**RE: North Houston Highway Improvement Project [NHHIP] – CSJ 0912-00-146
– Addendum 1 to Visual Impact Assessment Report / Draft Noise Technical
Report**

Following are the Houston Parks Board's [HPB] comments regarding TxDOT's recent release of the Visual Impact Assessment and Draft Noise Technical Report of the NHHIP. These comments support the Make I-45 Better Coalition's further comments regarding these technical reports and the accompanying Noise and Hazardous Materials report.

White Oak Bayou Greenway

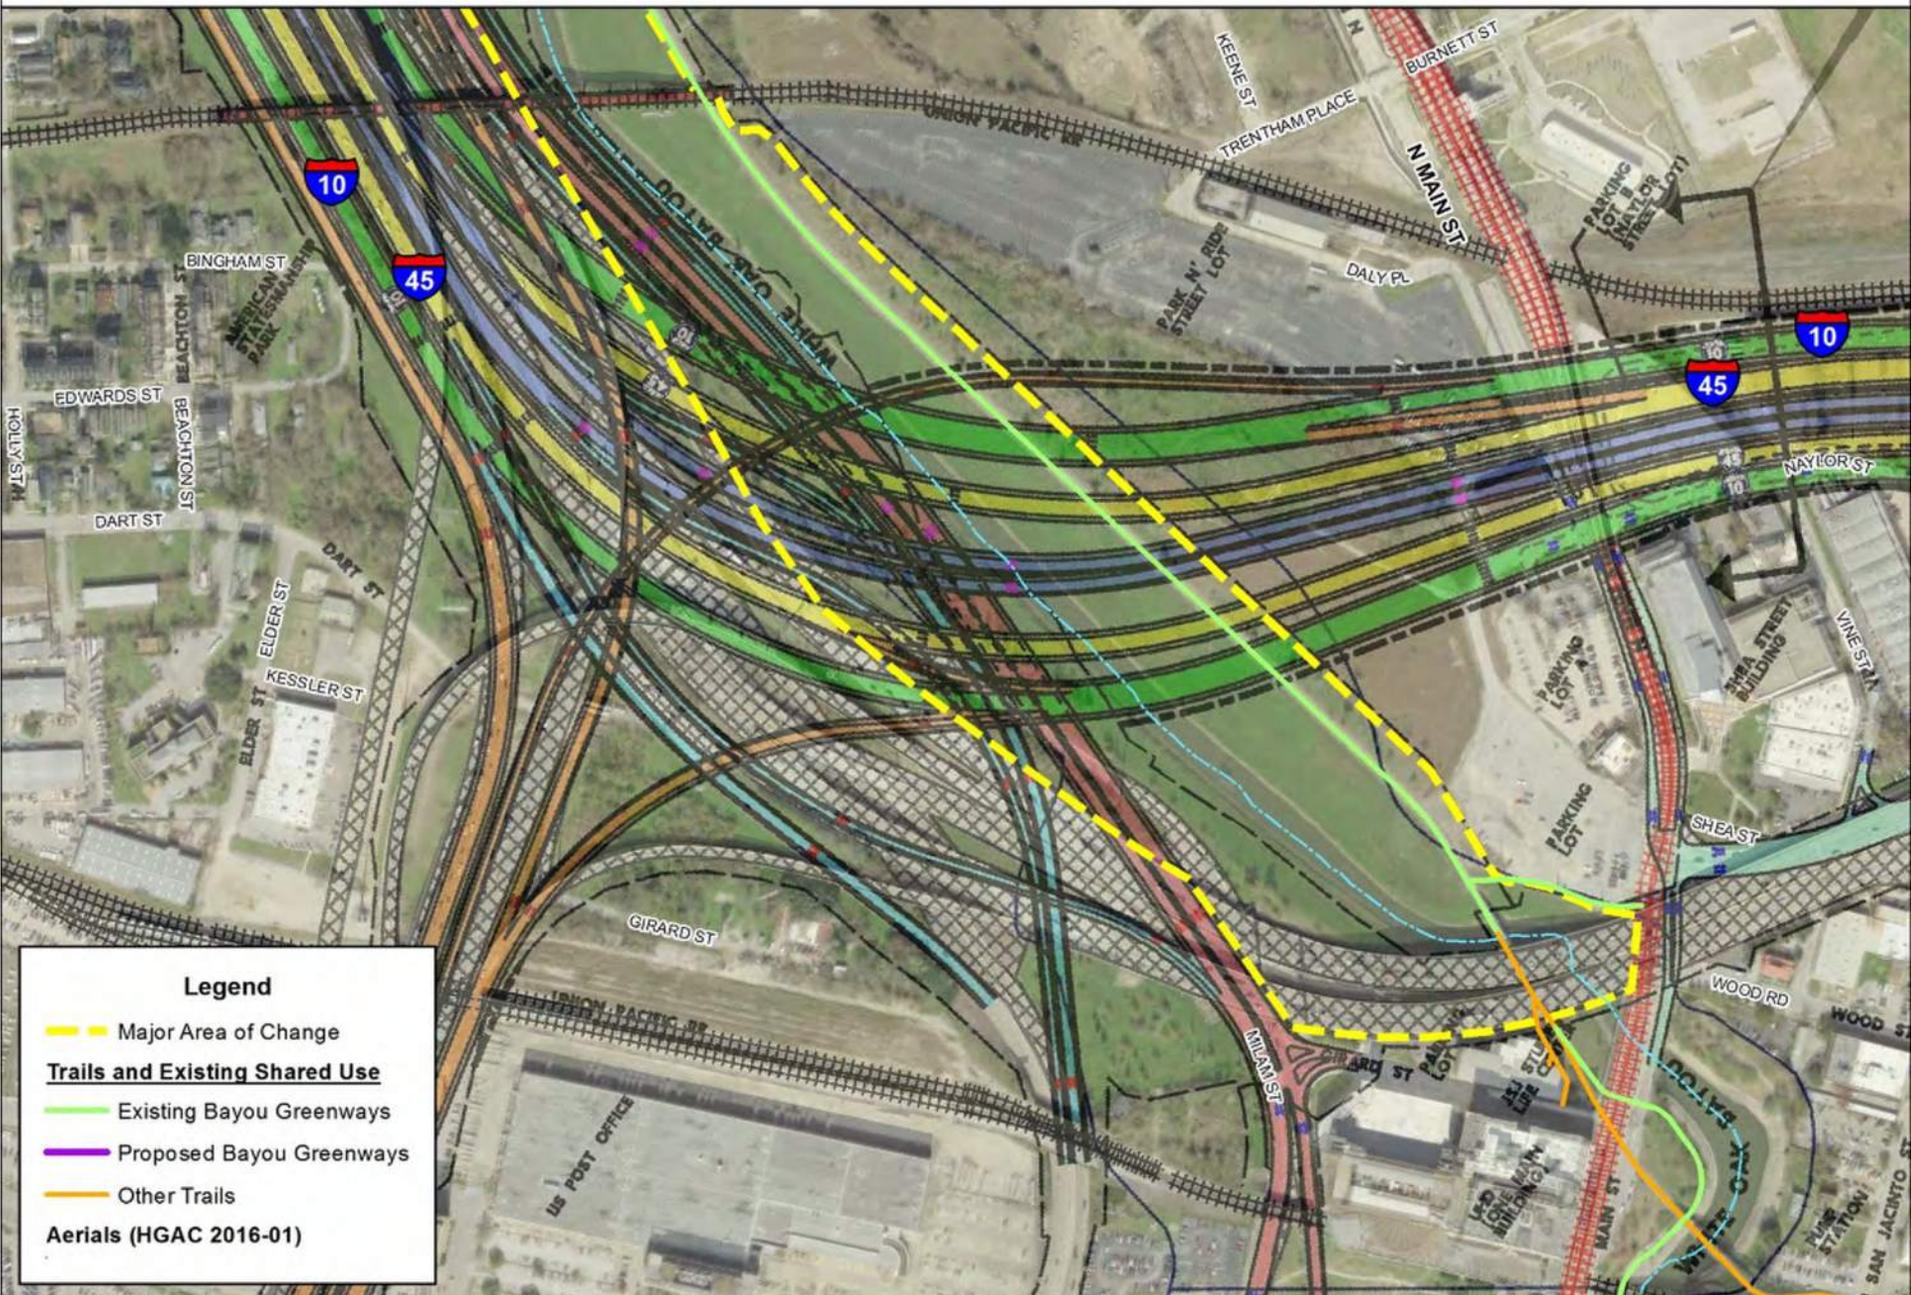
While the project eliminates the I-10 overpass adjacent to UHD, that present alignment is massed with the UHD buildings and Main Street minimizing the overall impact. However, The NHHIP reroutes 20 lanes of highway with some 7 new overpasses directly over the presently open parkland upstream of UHD. That impact is far more significant both qualitatively and in its overall scope and scale than what would be removed. HPB had previously noted a net impact to

18 acres of open space. The report's Figure 4 illustrates the new overpasses as a distant image, unrelated to the parkland it impacts. "Miscellaneous aesthetic improvements" are offered as mitigation.

HPB had commissioned its own visual impact analysis of NHHIP at White Oak Bayou Greenway Park (Exhibit A). We have shown it to a number of community groups over the past year. At each showing it elicits strong reactions of surprised shock. Again, the visual impact analysis should have been included in the DEIS so that the public could understand the significant impact during the main comment period.

Figure 6: White Oak Bayou at Heights Bike Trail – Proposed NHHIP

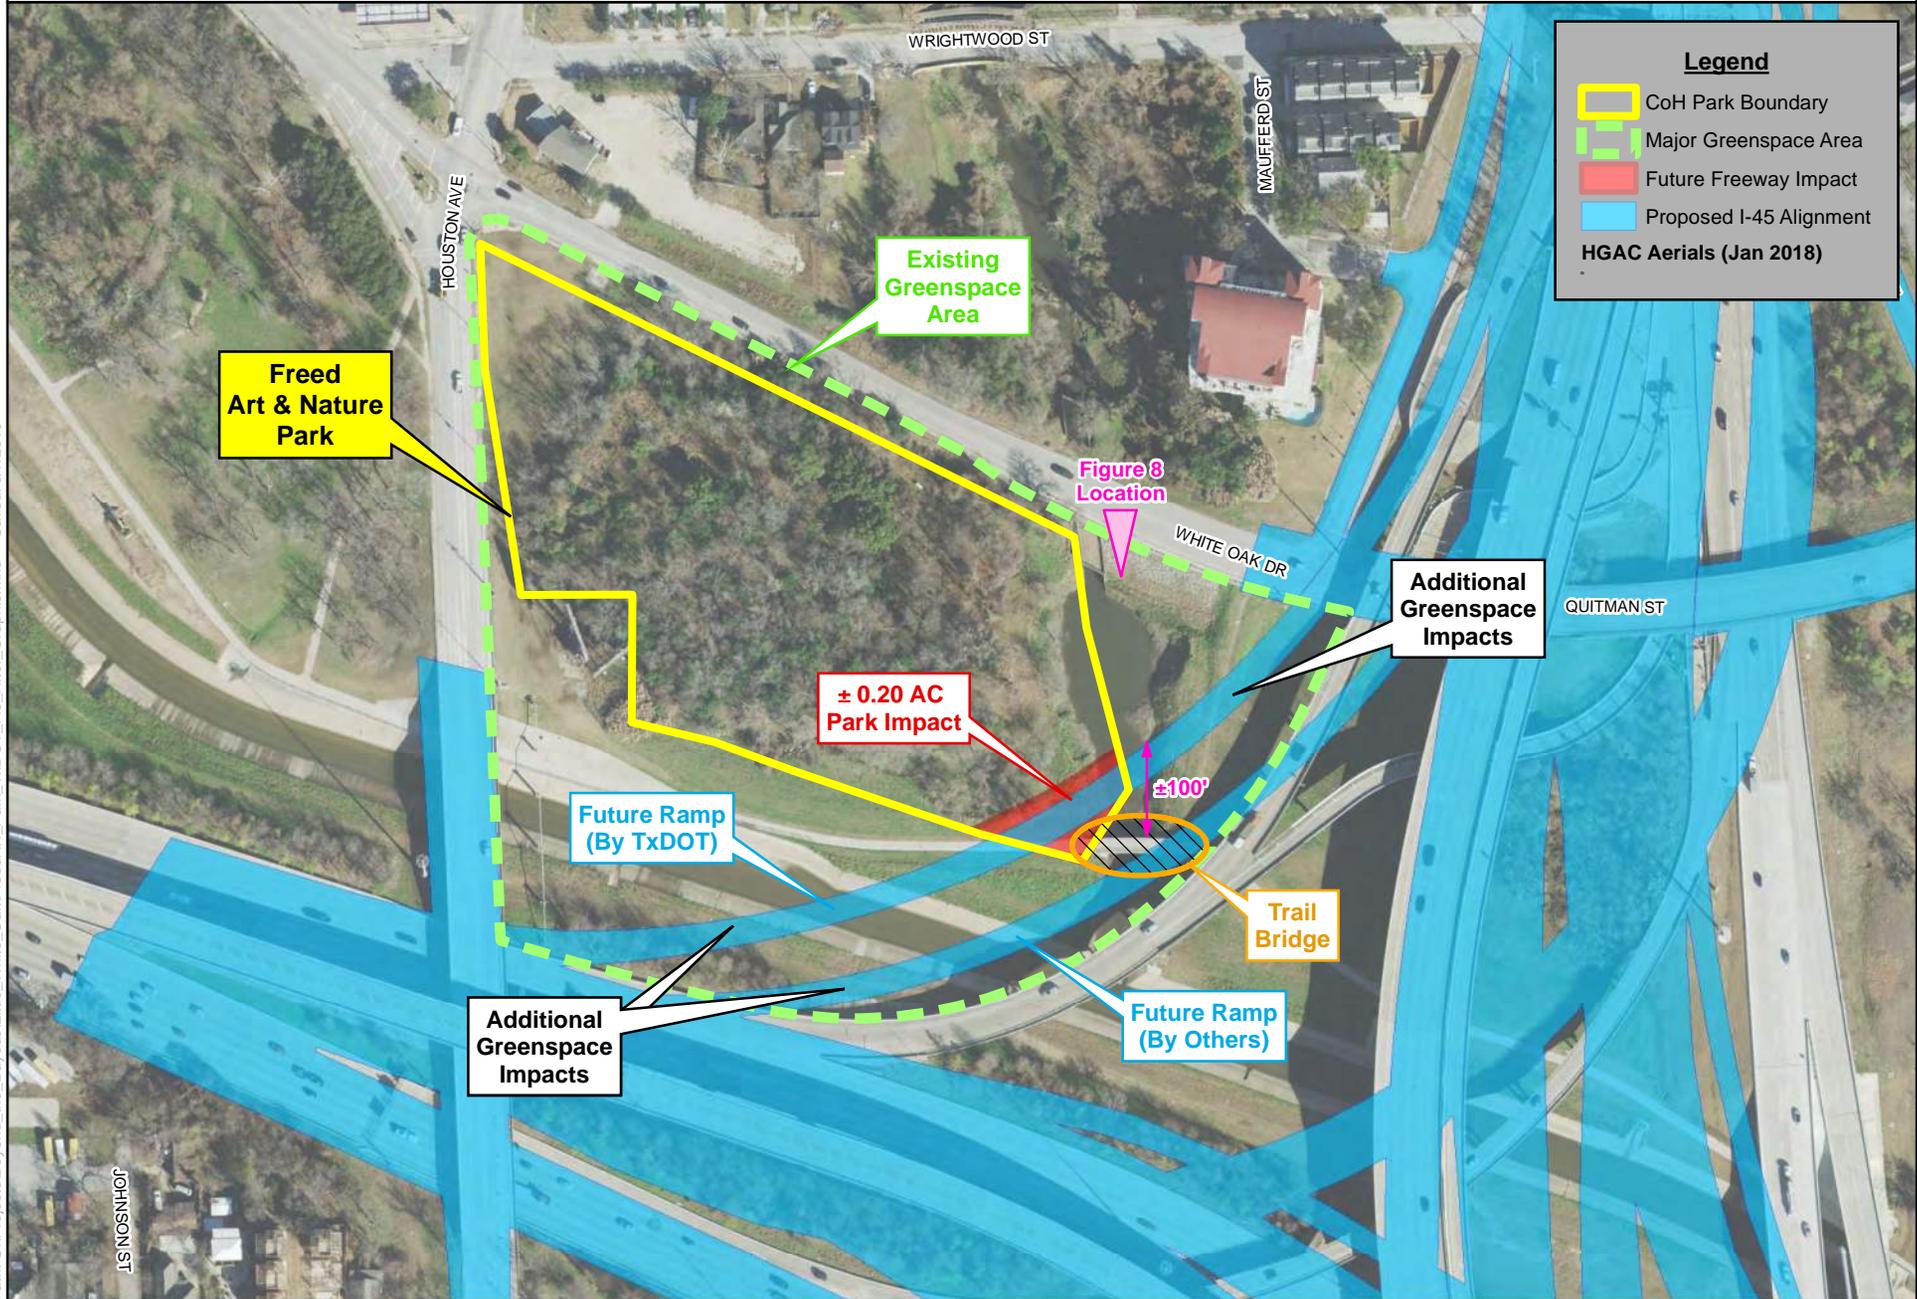
The report states that, “The existing visual quality on the Heights Bike Trail at White Oak Bayou is moderate, as no large elevated transportation facilities obstruct the view of Downtown (figure 5); however, the bayou has moderate to moderately low quality visual appeal because there are no improvements to the bayou or concrete drainage system to enhance the quality of landscaping in the area.” However, since the bayou has grass and wild flowers to its edge in this area (not concrete), and there is a line of trees that blocks the view of the current alignment of I-10, we contend that the current view of Downtown from the trail (Figure 5) is high visual quality. As it pushes a combined I-10 and I-45 against the very edge of White Oak Bayou’s southern shoreline, the NHHIP project obliterates the tree line that currently blocks views of present I-10 looking toward downtown. Along with the new elevated overpasses, this changes the view quality from high to low. The report’s Figures 5 and 6 do show that impact even as it distracts the analysis with images of park benches and canoes. Nor are the before and after views comparable. The canoes and water shown in Figure 6 would not be visible without realigning the bayou, which to our understanding is not planned and therefore should not be shown in the rendering.
